Access Compliance Report

Public Rights-of-Way

(Curb Ramps)

Intersection ID: 12342	Main Street: E_8TH_ST	Cross Street: N_CALDWELL_ST	Location: S
ADA ID: EFCCCB56E8D0	Ramp Type: PerpDiag	Initial Pass/Fail: Fail	Overall Compliance: No
Severity Score: 37.5			
Codes/Mitigation Info/Possible Solution		Field Measurements/Component Compliance

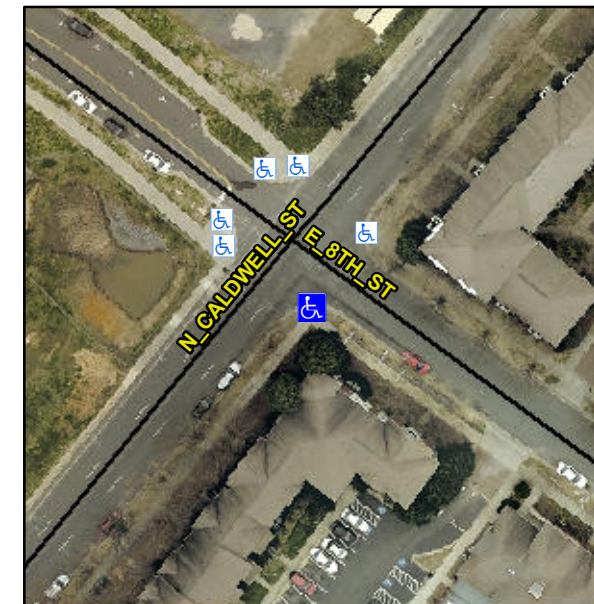
Not Found, R304.2.2, R304.5.3

Compliance	Description	Data	Compliance	Description	Data
N/A	Ramp Length (in)	41.0	No	Ramp Slope (%)	11.4
Yes	Ramp Width (in)	64.0	No	Ramp XSlope (%)	7.2
N/A	Flare Type LT	N/A	N/A	Flare Type RT	N/A
N/A	Flare Slope LT (%)	N/A	N/A	Flare Slope RT (%)	N/A
N/A	Flare Traversable LT?	N/A	N/A	Flare Traversable RT?	N/A
N/A	Landing Length (in)	N/A	N/A	DWS Provided?	N/A
N/A	Landing Width (in)	N/A	N/A	DWS Contrast?	N/A
N/A	Landing Slope (%)	N/A	N/A	DWS Length (in)	N/A
N/A	Landing X Slope (%)	N/A	N/A	DWS Full Width?	N/A
N/A	Landing Curb? (Y/N)	N/A	N/A	DWS Offset (in)	N/A
N/A	Shared Landing?	N/A			
N/A	Gutter Ponding?	N/A	N/A	Gutter Slope (%)	N/A
N/A	Gutter Lip Ht (in)	N/A	N/A	Gutter X Slope (%)	N/A
N/A	Painted X Walk1?	No	N/A	Painted X Walk2?	No
	X Walk 1 Direction	To NE		X Walk 2 Direction	To NW
N/A	X Walk 1 Width (in)	N/A	N/A	X Walk 2 Width (in)	N/A
	X Walk 1 Slope (%)	5.0		X Walk 2 Slope (%)	8.7
	X Walk 1 X Slope (%)	3.7		X Walk 2 X Slope (%)	1.4

N/A	Ramp inside XWalk1?	N/A	N/A	Ramp inside XWalk2?	N/A
	Road Slope (%)	6.2	N/A	Clear Space?	N/A
	Road X Slope (%)	4.3	N/A	Clear Space to XWalk (in)	N/A
N/A	Any Obstructions?	N/A	N/A	Storm Grate/Utility Hazard?	N/A
	Obstruction Type			Storm Grate/Utility Type	
		N/A			N/A
		Yes		Surface Condition? (G/P)	Good

Remove & Replace Curb Ramp With Two New Directional Ramps or Equivalent.
